Service Letter: 453

Title: Shroud to Nosebowl Clearance

Models: 8KCAB (AEIO-390-A1B6 engine, serial numbers 1185-2020 and prior)
8GCBC (IO-390-A1B6 engine, serial numbers 602-2020 and prior)

Figure 1, Shroud Clearance

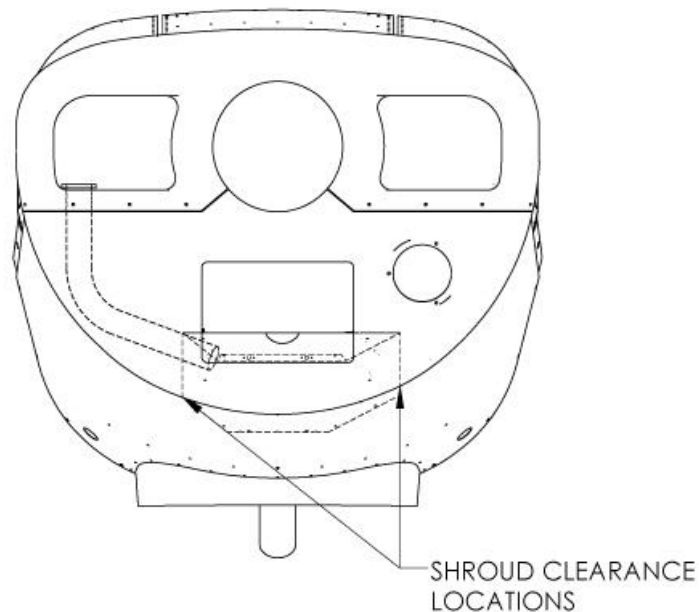
1. Open left and right cowl doors (8 camlocks).
2. Remove cable ties securing landing light harness to lower cowl (2 ties, left side).
3. Remove lower cowl (15 screws).
4. Inspect nosebowl for abrasion at locations shown in figure 1 (nominal clearance is $\frac{3}{8}$ inch). Cowl fit may reduce clearance to a point that engine movement results in abrasion.

5. If abrasion of nosebowl is noted modify shroud per following section (after modification visually inspect for $\frac{3}{8}$ inch clearance). Repair or replace lower nosebowl if abrasion exceeds $\frac{1}{2}$ the nosebowl thickness (contact American Champion for repair procedure).
6. If wear is not present clearance is adequate. Inspect at next 100-hour or annual inspection.
7. Reinstall lower cowl in accordance with AMM. Secure landing light harness with VUVT-06M or equivalent cable ties (2 each required). Close cowl doors (8 camlocks).

1. Remove and disassemble exhaust and shroud per the AMM.
2. Replace left shroud panel with 3-1789 revision B or later approved revision and 3-1854-2 seal (install seal with 4 screws and washers). Right shroud panel may be replaced with 3-1790 revision A or later approved revision and 3-1854-3 seal (install seal with 3 screws and washers). Replace 4-2131 shroud panel (outer wrap) with revision B or later approved revision. Discard replaced shroud panels. Alternately a replacement shroud may be fitted per service letter 454.
3. Assemble and install exhaust with replacement panels per the AMM.
